Remedial Investigation Work Plan Addendum 1,
Bethpage Community Park, Former Grumman Settling Ponds (Operable Unit 3),
Bethpage, New York.

Date:
13 June 2005

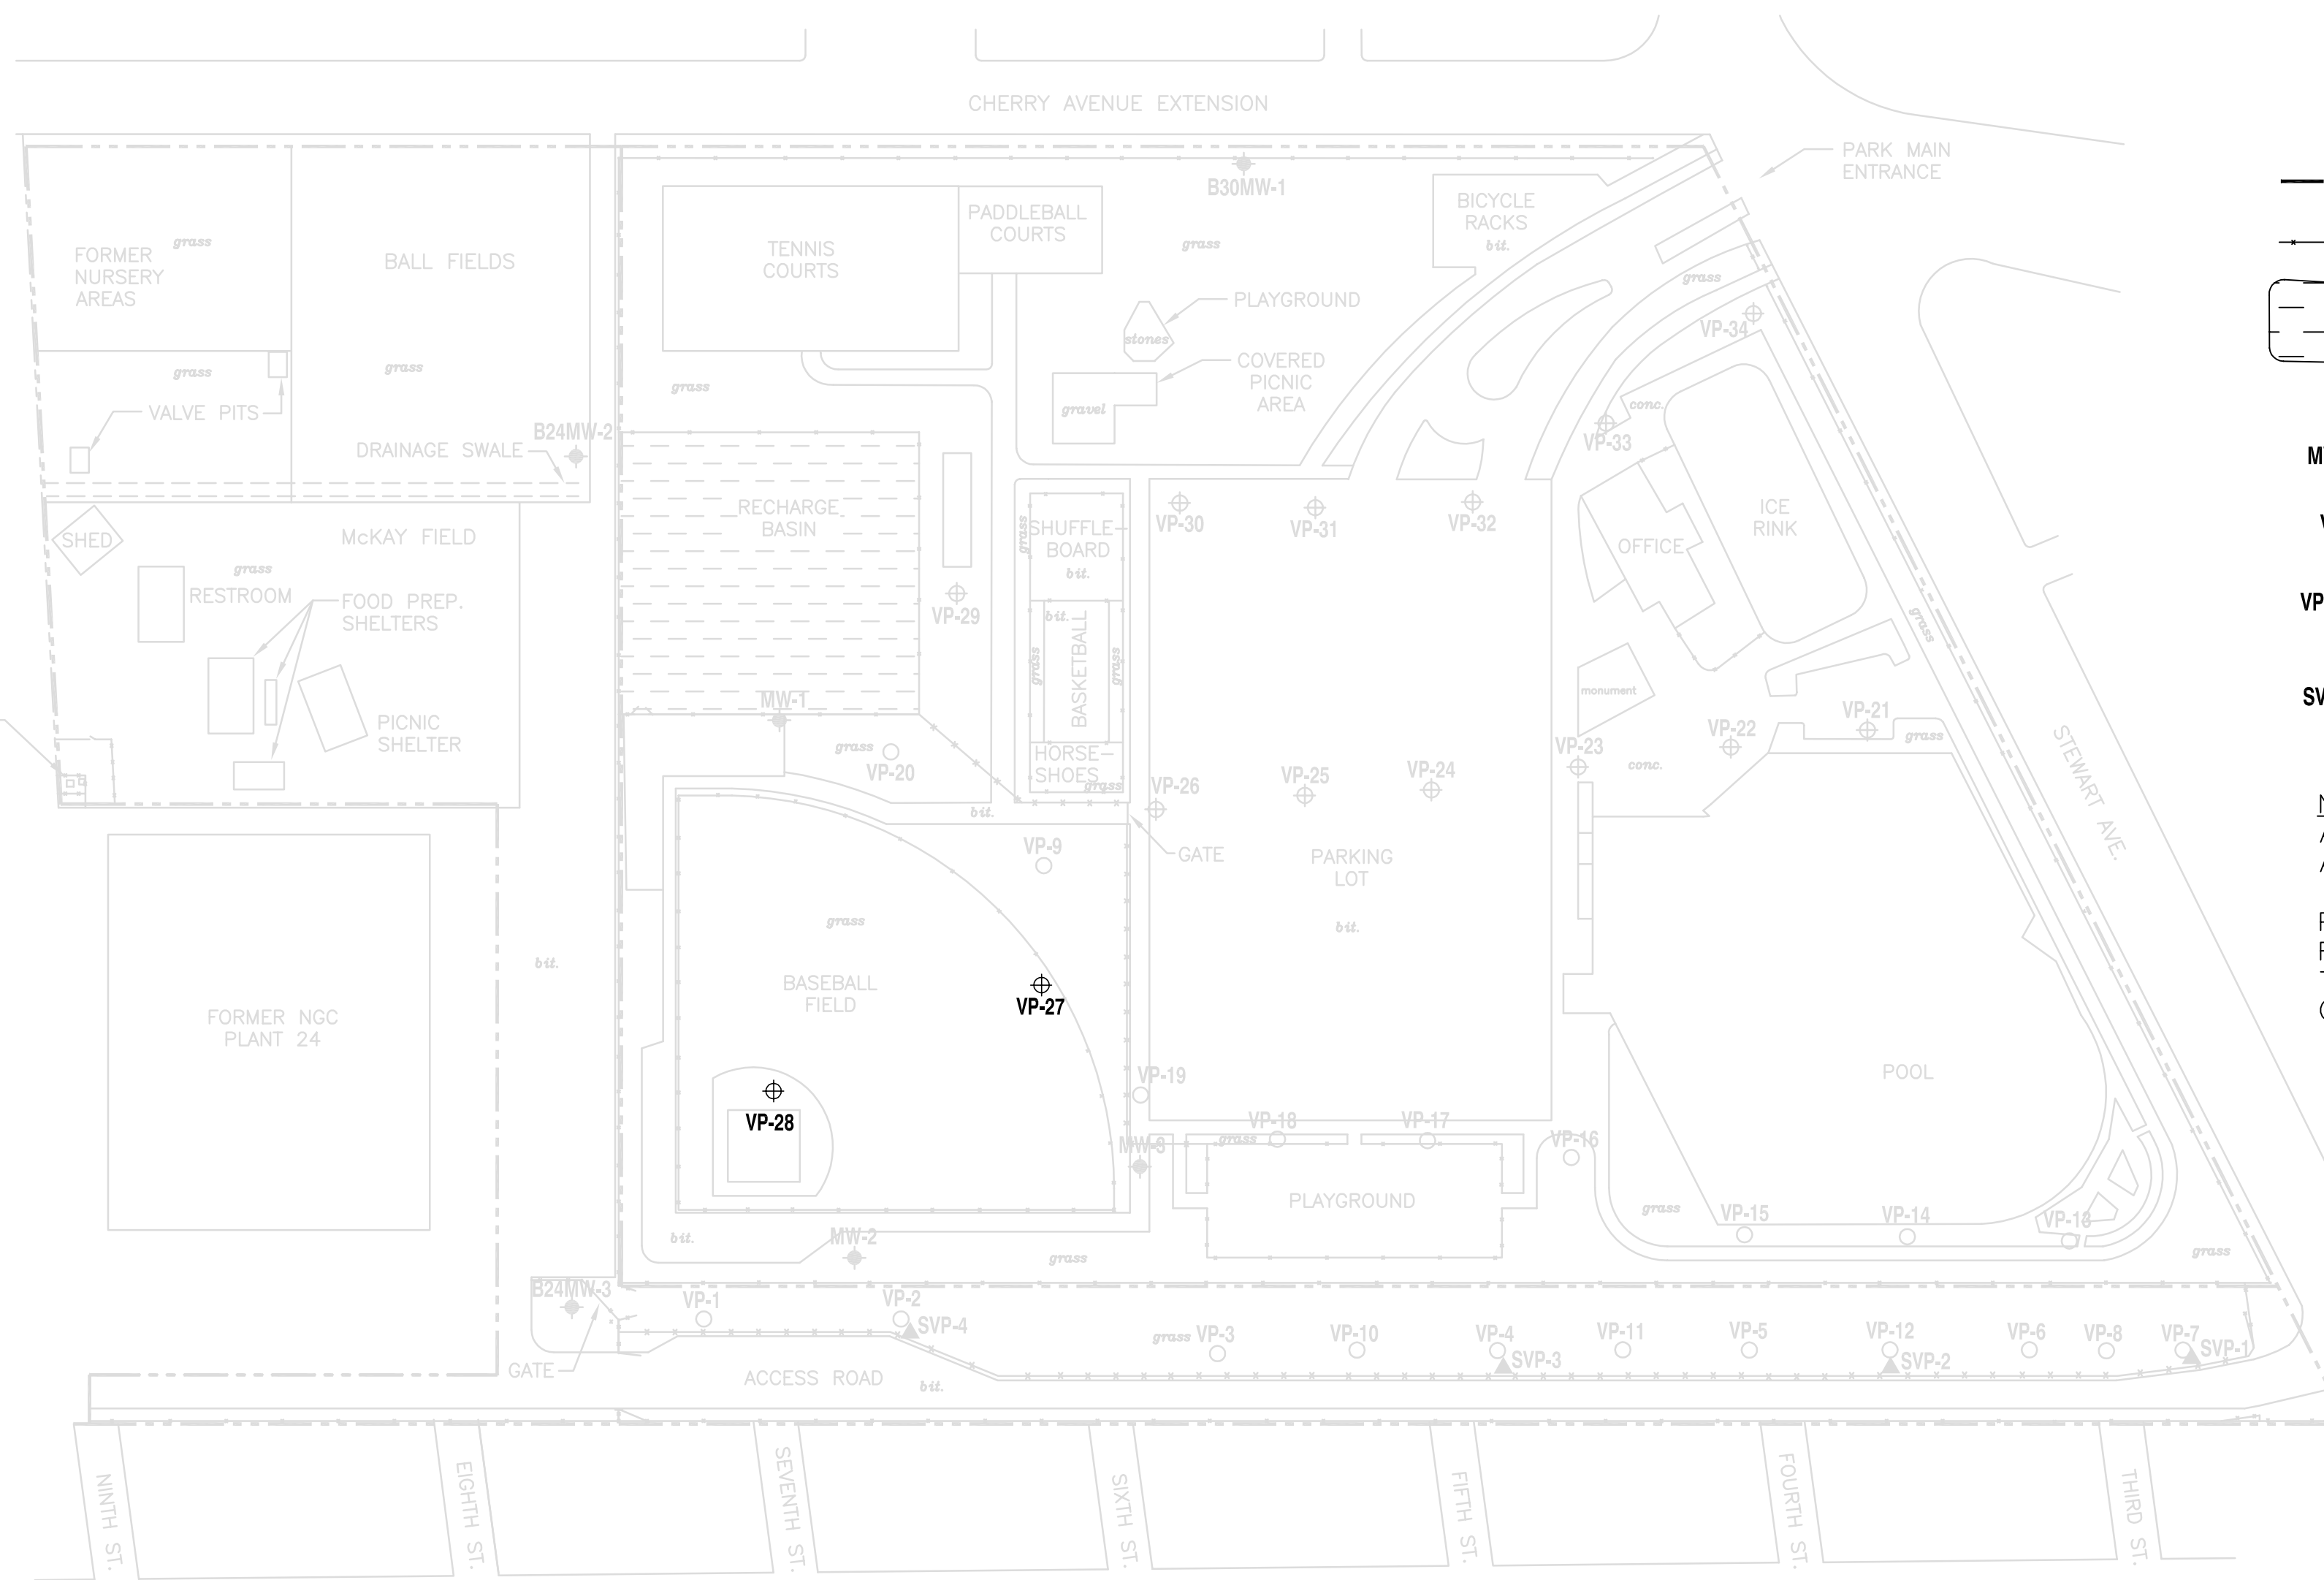
- Vertical Profile Borings (VPBs):** Two VPBs (VPB-27 and VPB-28) are proposed to investigate two former operational areas on the current Park property, known as the "Former Rag/Oil Pit" and the "Former Short-Stop Basin". The six contingency VPBs that were originally proposed in the May 16, 2005 Phase 1B RI work plan are not affected by this additional work scope and remain as contingency VPBs, however they have been re-numbered as "VP-29 to VP-34" to account for these two new VPBs.
- Data Evaluation:** ARCADIS will review, summarize, and interpret the data collected in the above task using methods similar to those described in previous work plans.

The objective of this addendum is to fill data gaps in two operational areas: 1.) The former Rag/Oil Pit and 2.) The former Short-Stop Basin. The investigation will develop information to refine delineation of known VOC and semi-volatile organic compound (SVOC) impacts to soil and assist in determining if these two areas are sources of VOC impacts to groundwater.
